Index 700-102 Special Sign Details

COMMENTARY

COMMENTS AND RESPONSES

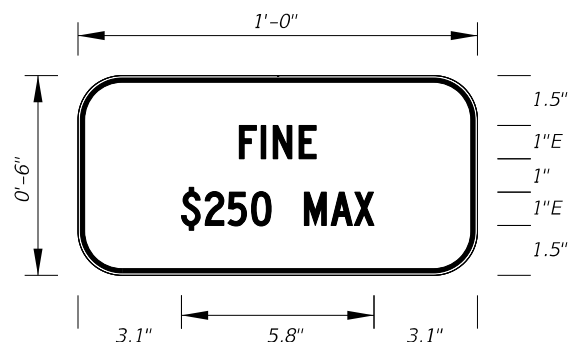
COMMENT: It's not clear the total number of yellow flashers to be installed in FTP-022-25 and FTP-022A-25 signs.

RESPONSE: Thank you for your comment. These signs have been updated to remove the middle flashing beacons.
